1. *Discuss any trends in the amount of primary-to-secondary leakage observed during the recently completed cycle.*

SG2A Indication Totals - 4/12/2016 11:58 AM

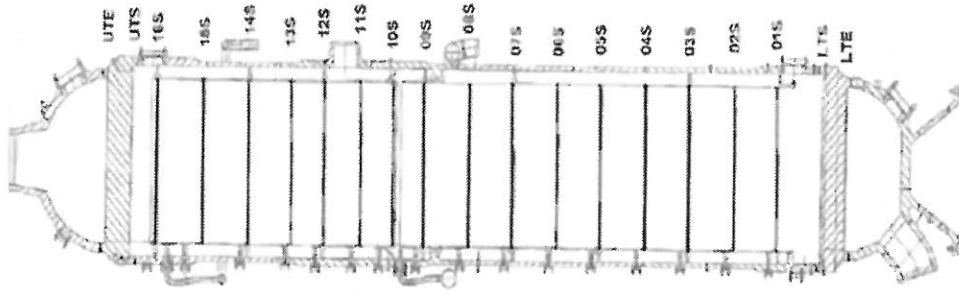
5. *For each area examined (e.g., tube supports, dent/dings, sleeves), provide a summary of the number of indications identified to-date for each degradation mode (e.g., number of circumferential primary water stress corrosion cracking indications at the expansion transition). For the most significant indications in each area, provide an estimate of the severity of the indication (e.g., provide the*

*voltage, depth, and length of the indication). In particular, address whether tube integrity (structural and accident induced leakage integrity) was maintained during the previous operating cycle. In addition, discuss whether any location exhibited a degradation mode that had not previously been observed at this location at this unit (e.g., observed circumferential primary water stress corrosion cracking at the expansion transition for the first time at this unit).*

Based on current inspection results, all flaws detected meet condition monitoring criteria for structural and leakage integrity and have done so for the entirety of the previous cycle.

The only degradation detected to date is wear at TSP intersections. This was expected and addressed in the Degradation Assessment. No unexpected modes of degradation have been identified.
